AGENDA
FARRAGUT MUNICIPAL PLANNING COMMISSION

June 16, 2016
7:00 p.m. Farragut Town Hall

SUBJECT: Discussion and public hearing on a site plan for Premier Eyecare, located at 11111 Kingston Pike, Parcels 22-24, Tax Map 143A, Group A, Zoned C-1 and FPD, 3 Lots, 2.22 Acres (Urban Engineering, Inc., Applicant)

SUBJECT: STAFF COMMENTS ON THE SITE PLAN FOR THE PREMIER EYECARE, 11111 KINGSTON PIKE

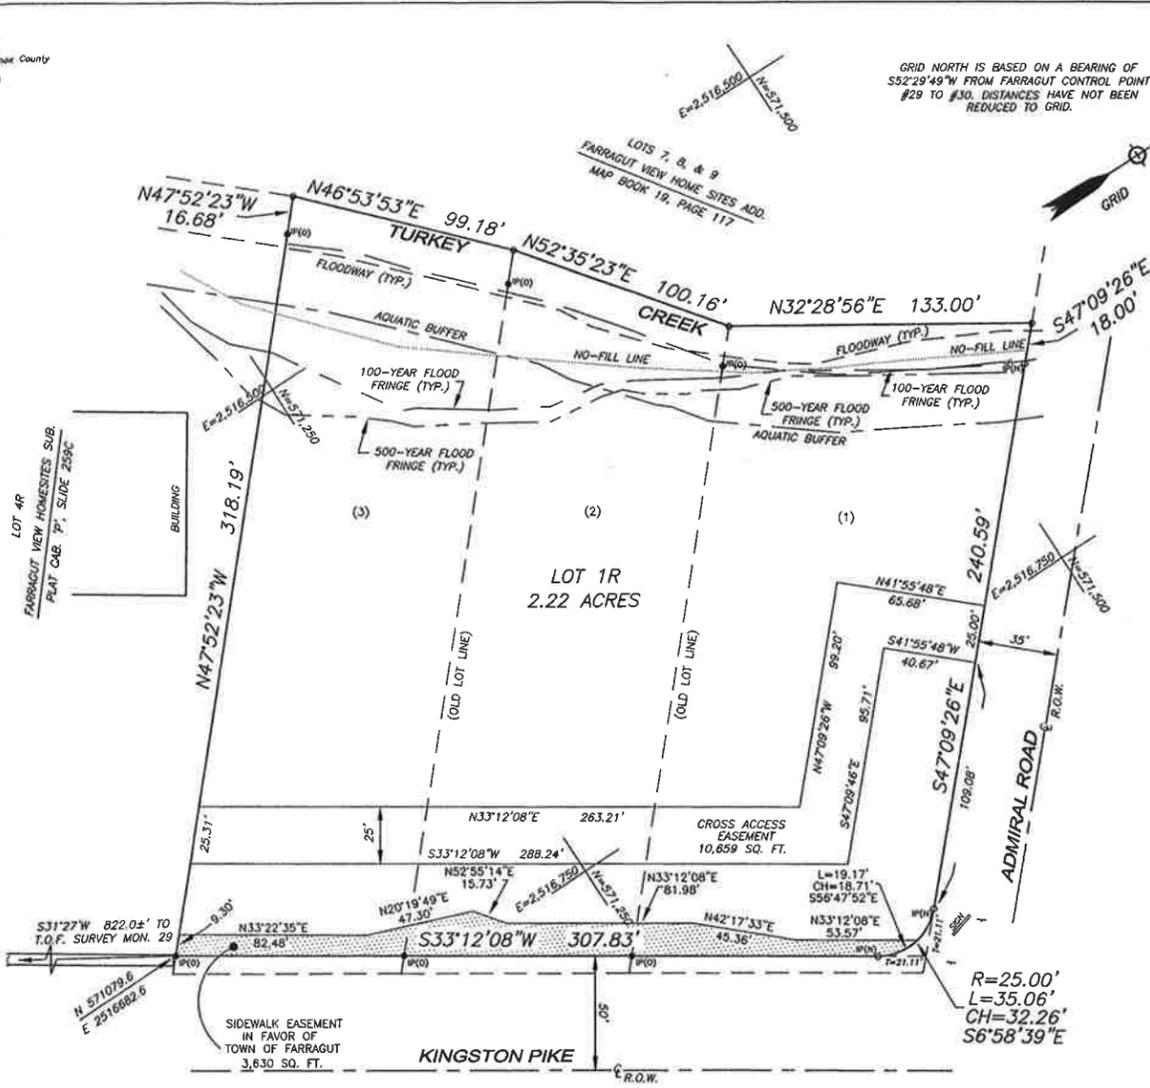
1. Related to the plat, a variance to the subdivision regulations will need to be specifically approved by the planning commission from the requirement to construct sidewalks on all collector streets which a subdivision fronts. Admiral Road is a collector street and the section of sidewalk that is requested for omission due to the stream crossing will have to be specifically approved as part of the plat consideration;

2. Please include a legend for the floodplain related lines and consider enhanced identification of these different lines so they are more distinct;
3. Please plat an access easement to the west to provide for a vehicular connection between the properties;

6. Please include the aquatic buffer note (checklist Item #32) as a numbered note on the plat; and
7. Please ensure that TDS does not add a stamp to the plat which essentially waives their release of easements. The Town will not sign the plat if this is on the plat to be recorded.

1. Comment noted.
2. A legend for the floodplain related lines has been added.
3. An access easement has been platted.
4. A note has been added to specify the MFE which meets the Town's requirement.
Please see note 9.
5. Note 7 has been modified to include the full map panel and effective date.
6. The aquatic buffer note has been added. Please see note 8.
7. Comment noted.

SHEET C-2 (SHEET 3 OF 15)

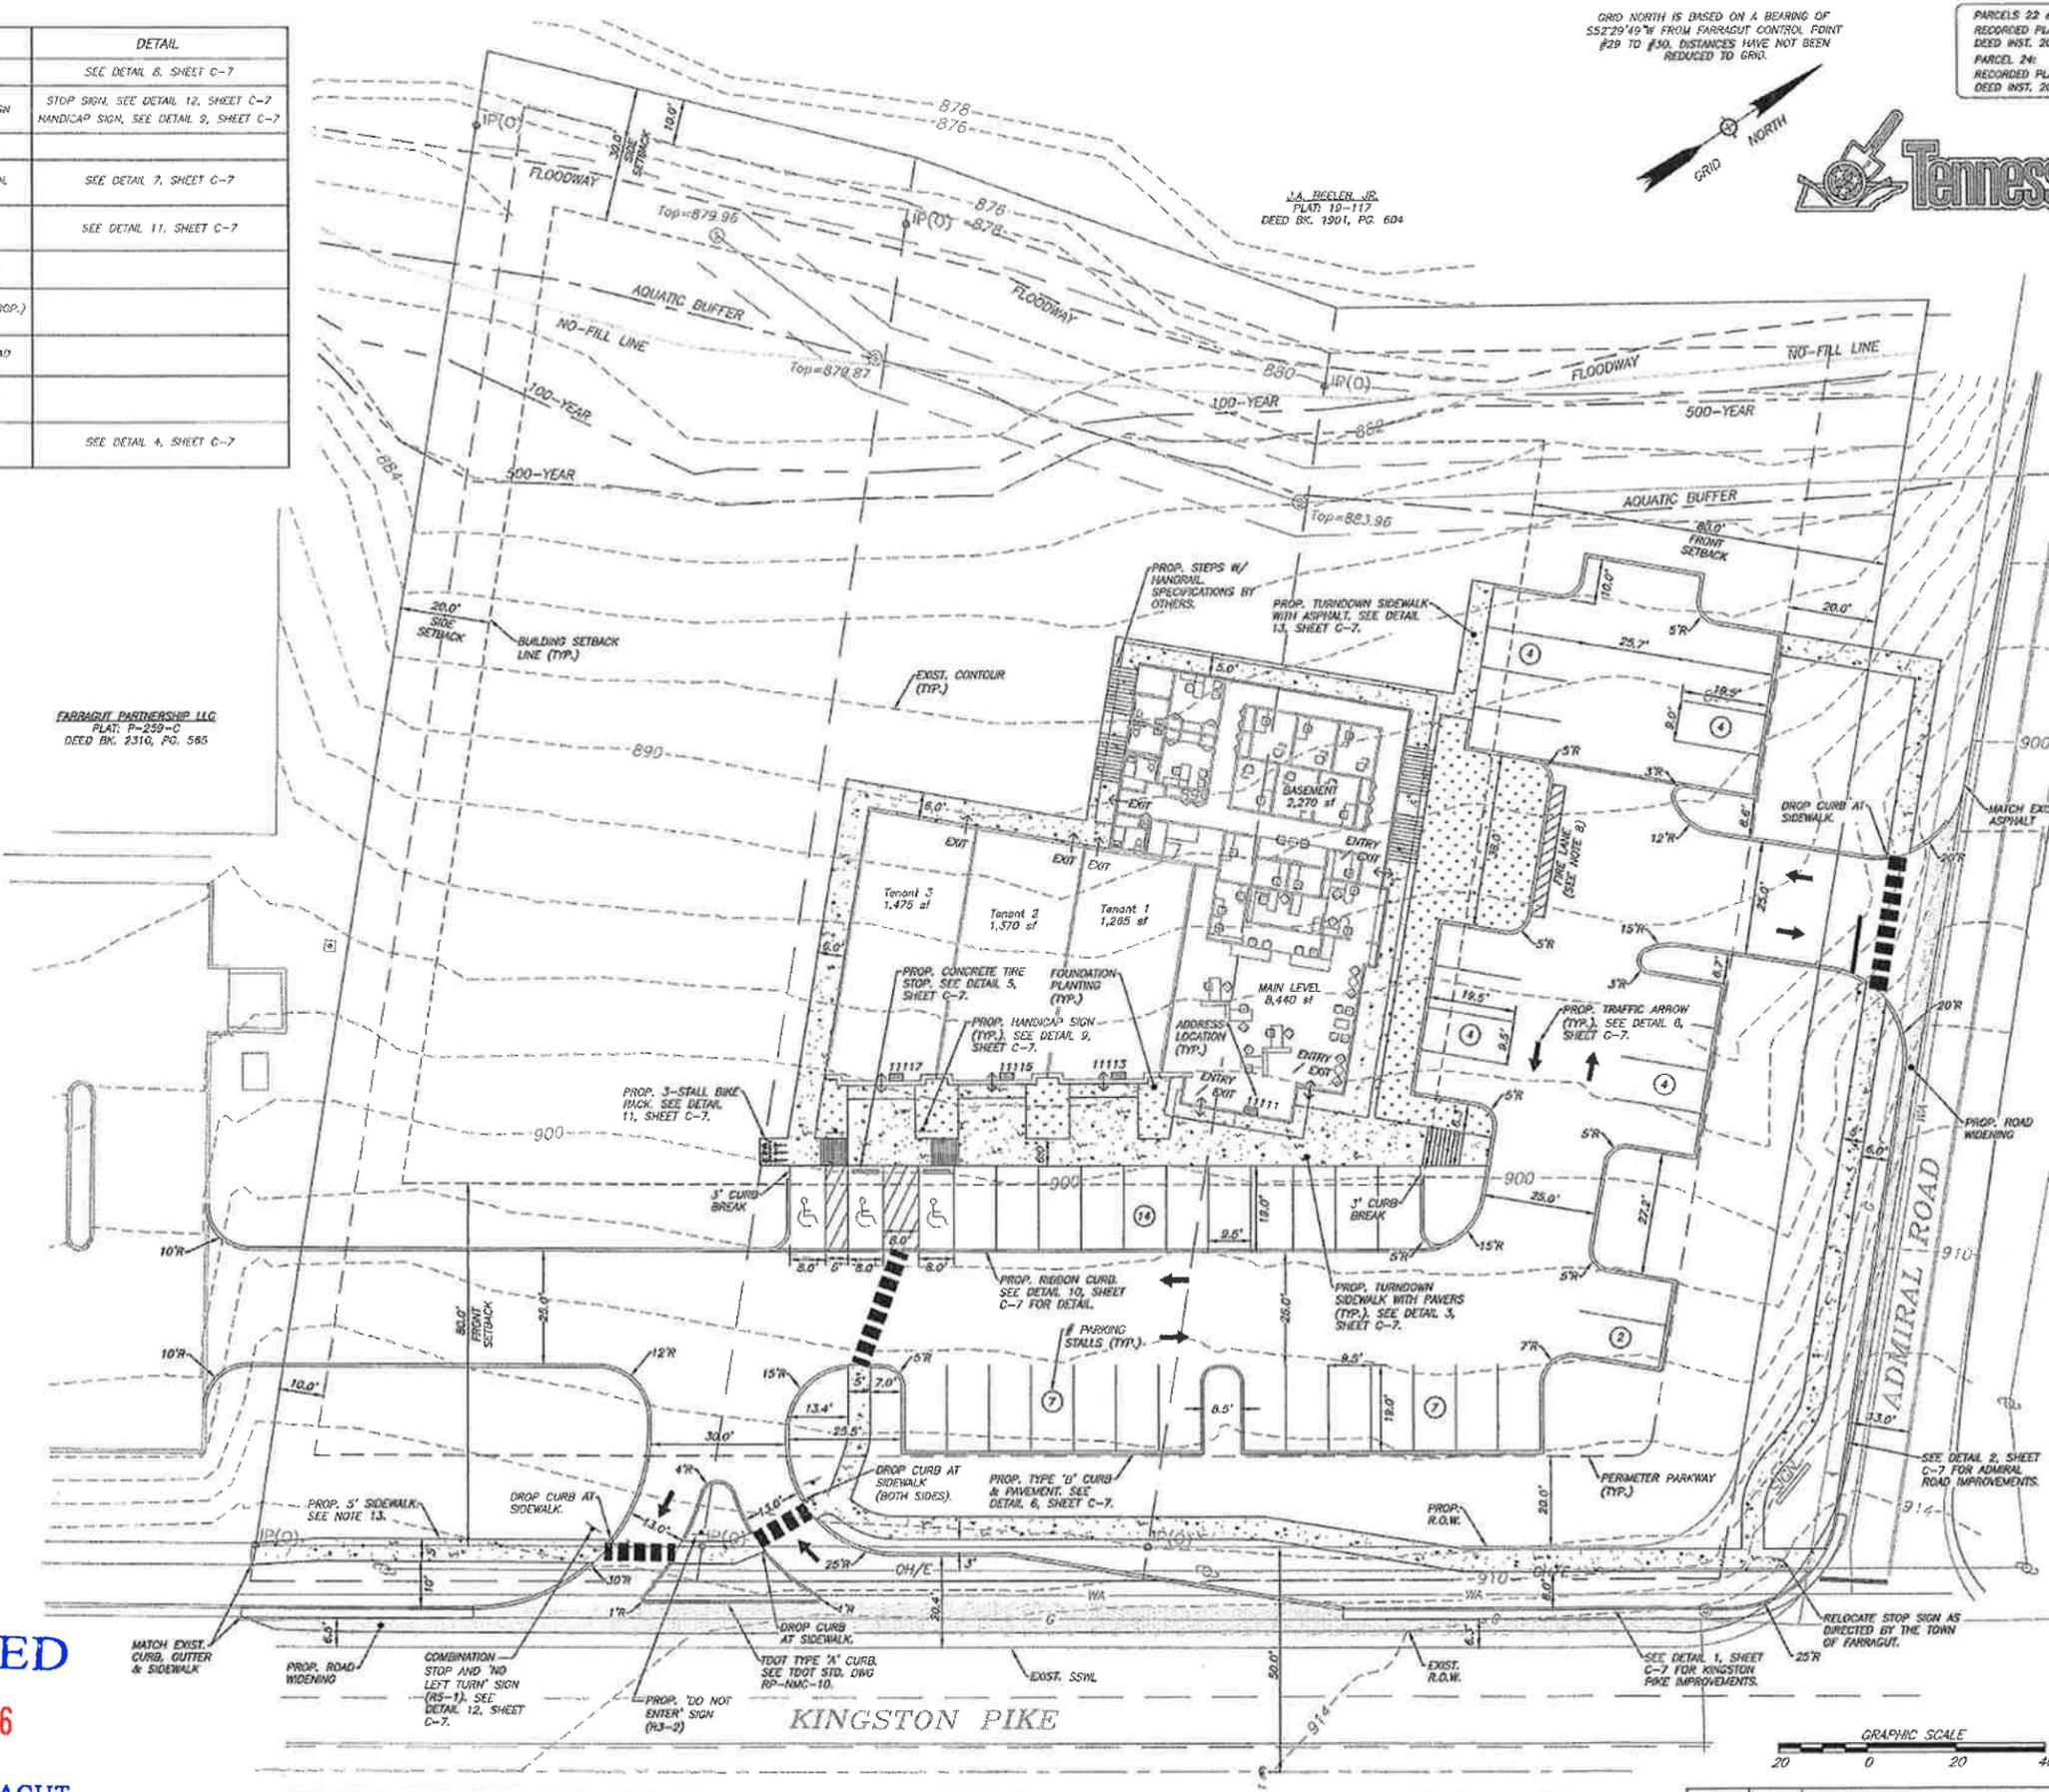
- 11) Please provide a vehicular connection to the property to the west;
- 12) Please make the radius more pronounced for the right out access onto Kingston Pike;

- 15) Please add an interior landscape island along the row of parking abutting Kingston Pike so as to create a smaller pod of parking in this visible location as governed by the ADS;

- 27) Please show all proposed HVAC units and how they are being screened by the building they are serving so that they are not visible from adjacent properties or rights of ways. Please also include a note on the plan which states that all HVAC units shall be screened by the building they are serving so that they are not visible from adjacent properties or rights of ways;
- 28) The landscape plan will be reviewed by the VRRB and requires a separate application. A grading permit cannot be issued until the landscape plan is approved;
- 29) Prior to the issuance of a Certificate of Occupancy a digital as-built will be required in a JPEG format;

10. The building will consist of 60% masonry. A note has been added to Sheet ELEV01.
11. The vehicular connection has been added per comment. Please see Sheet C-2. We have also proposed an access easement between the adjoining property to the west and Admiral Road. The easement is shown on the corrected plat.

12. The radius has been revised per comment. Please see sheet C-2.
13. Comment noted.
14. Comment noted.
15. The interior island has been added per comment. Please see Sheet C-2.

27. All proposed HVAC units are roof-mounted and will be screened by the building's parapets. The note referenced in the comment has been added to Sheet C-2 per comment (note 15).

SHEET C-4 (SHEET 5 OF 15)

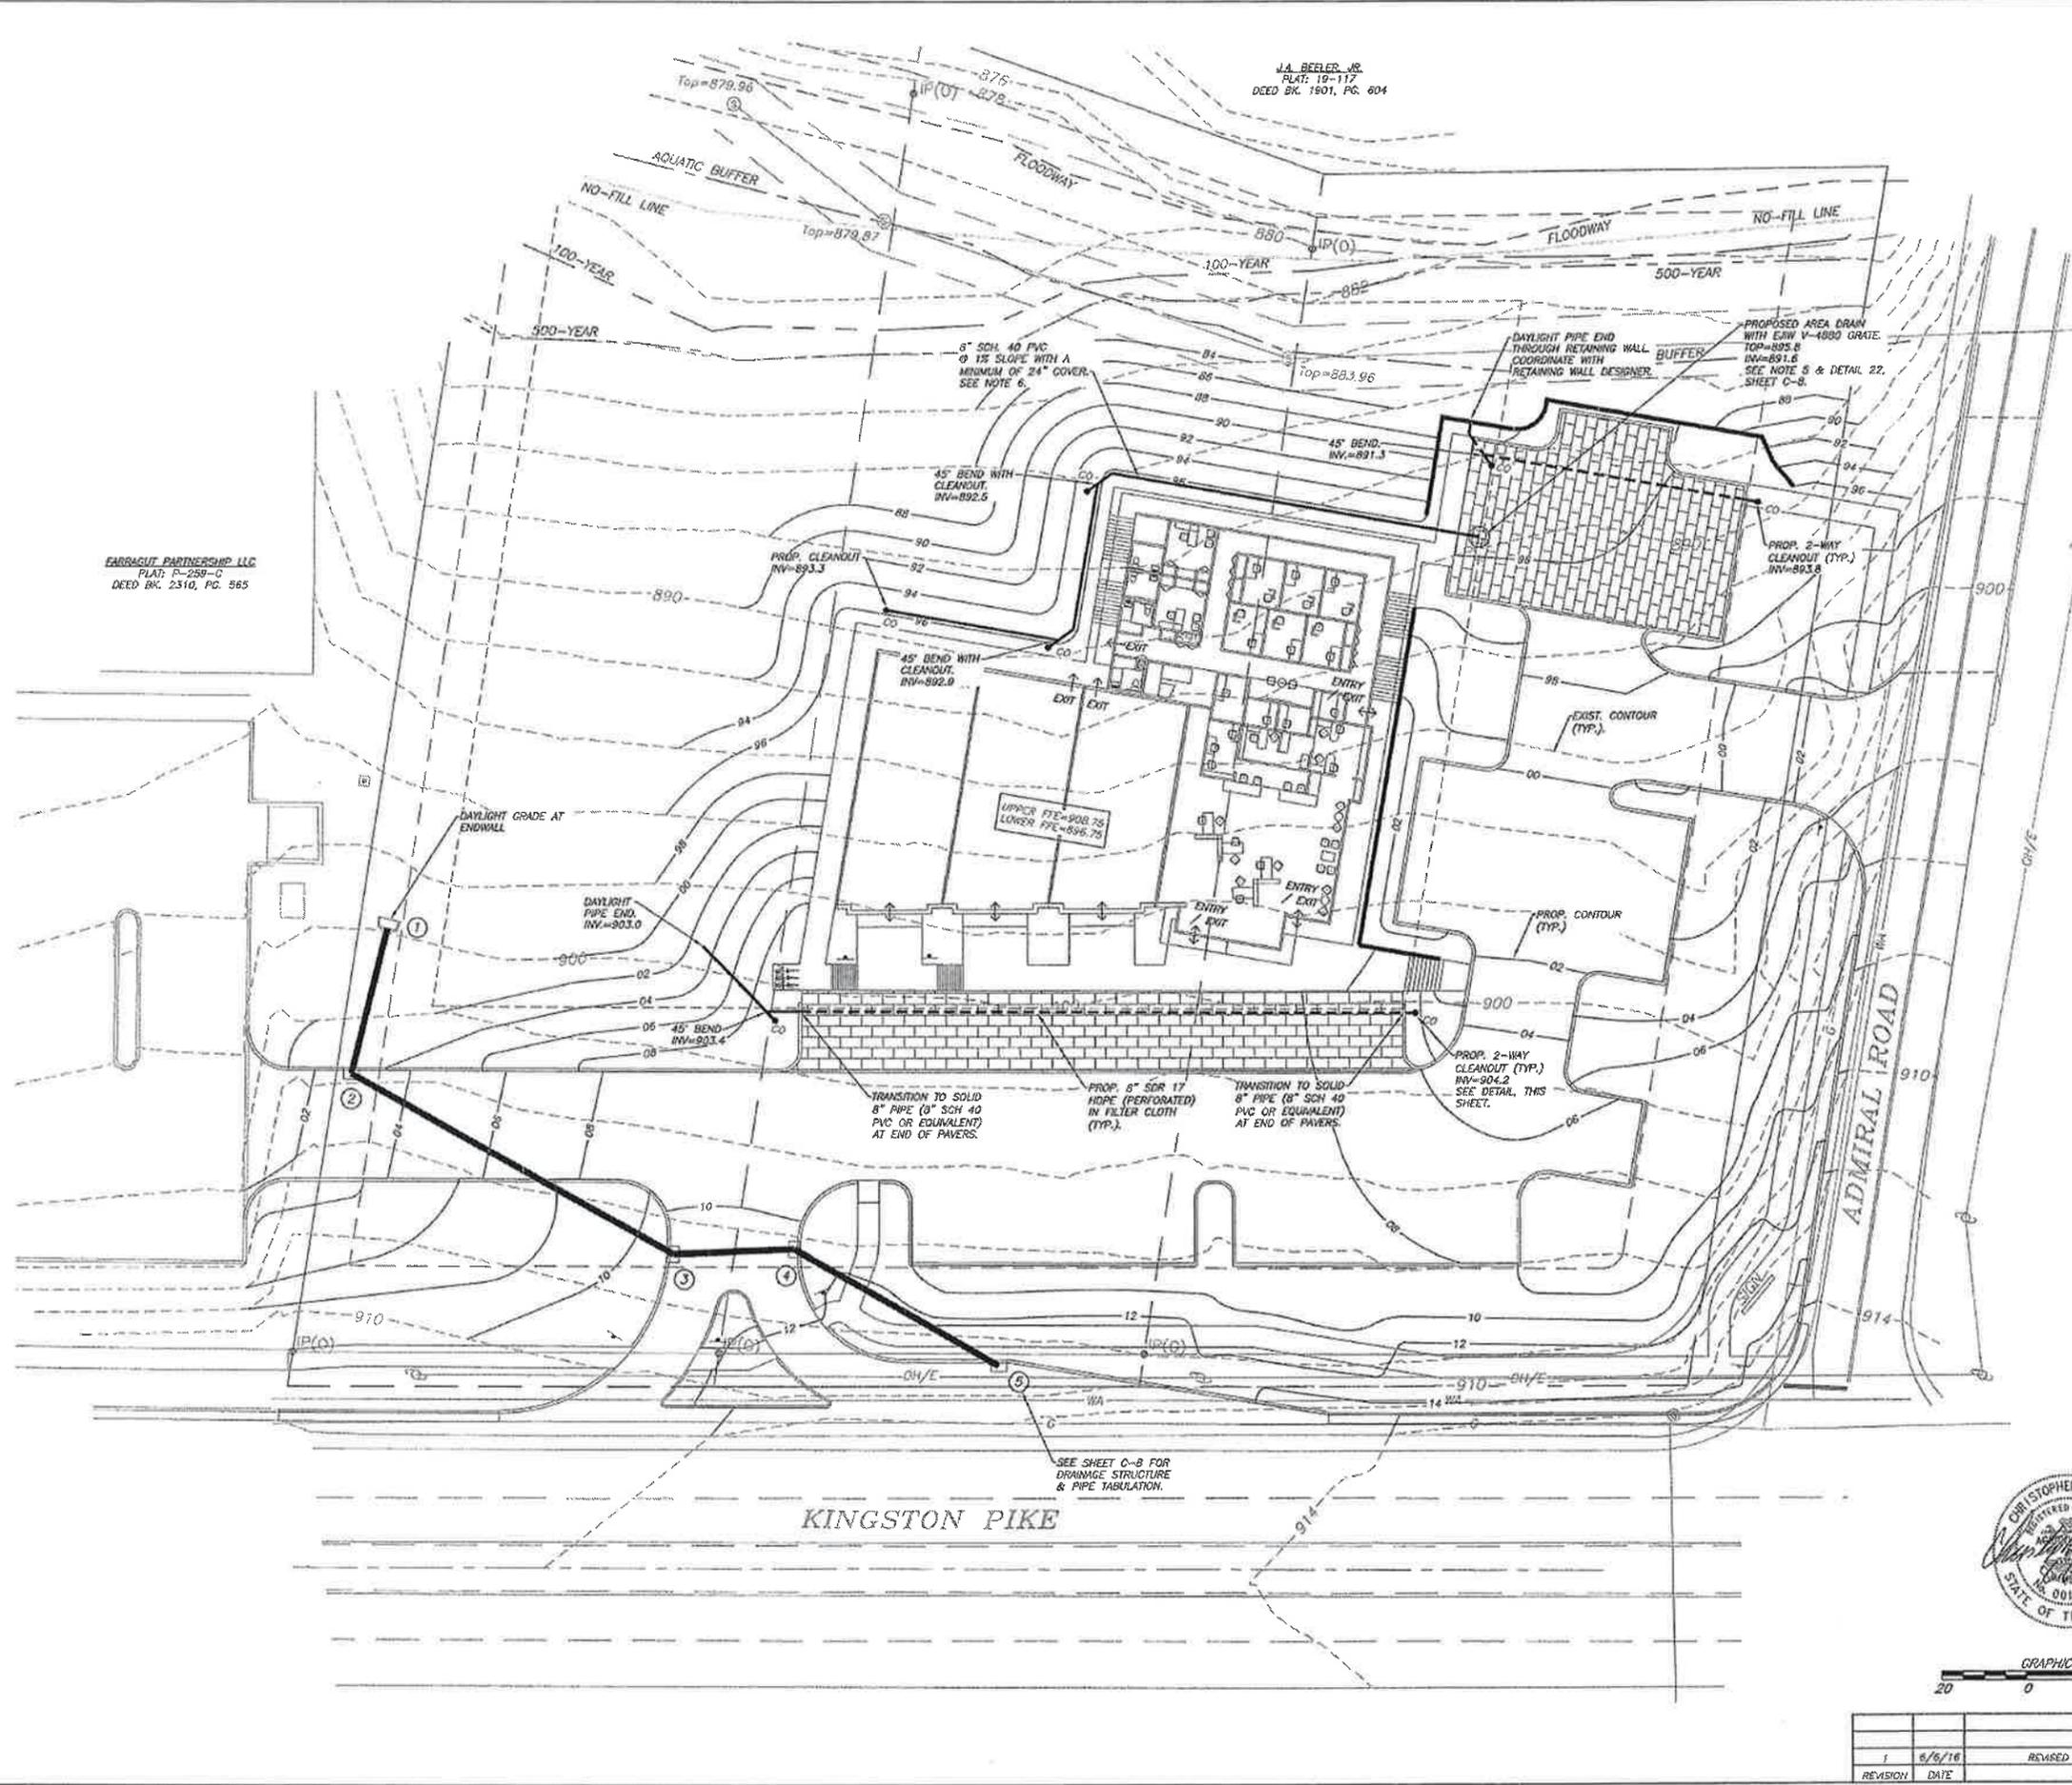
- 16) Though two rows of silt fence is shown on the plans, the staff would recommend that one of the rows be wire backed due to the proximity to the aquatic buffer;

16. The silt fence specification has been revised per comment. Please see Sheet C-4.
17. Comment noted.
18. Architectural sheets have been numbered in sequence with civil sheets per comment.

Sheet Title:
SHEET ELEV01 (SHEET 13 OF 15)

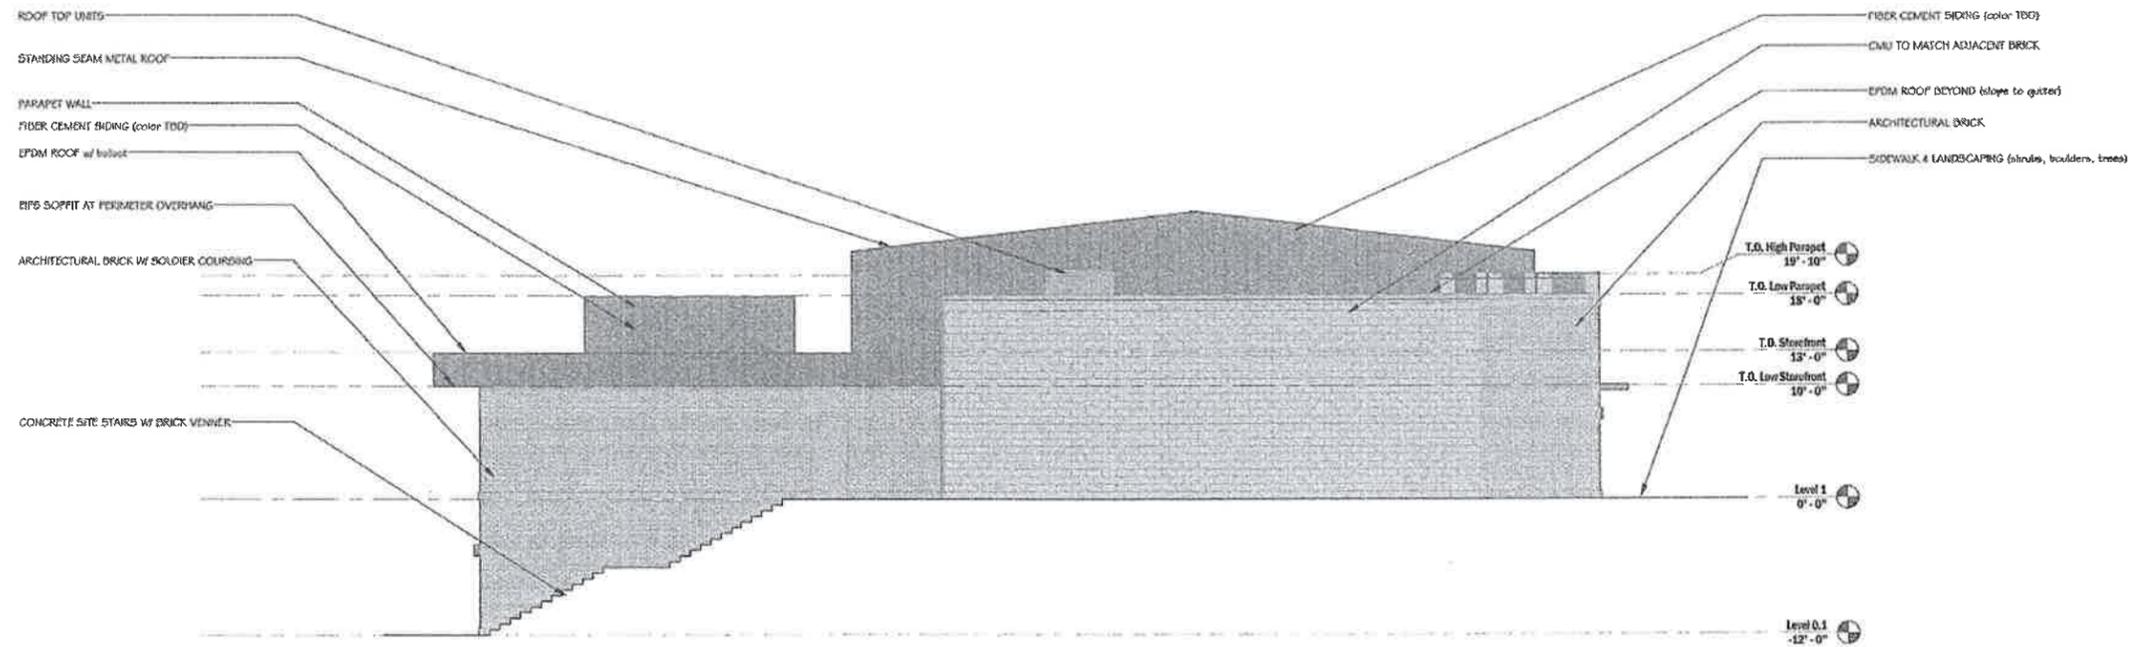
- 9) Please omit use of metal siding. This is not permitted in the Town's adopted Architectural Design Standards (ADS);
- 10) Please verify that the building will be at least 60% brick or stone on the net façade area;

- 24) Please show what the wall light fixtures will look like on the building and that they will not exceed 15 feet in mounted height;
- 25) Please remove all non-regulatory signage from this submittal. Signs are reviewed as part of a sign permit process and are not part of the site plan review;

19. Architectural signatures and seals have been added to Sheets ELEV01 and ELEV02 per comment.
20. The electric sheets have been sealed and signed per comment.

24. A dimension to the bottom of the exterior light fixture has been added to Sheets ELEV01 and ELEV02. A specification sheet has also been attached to this submittal.
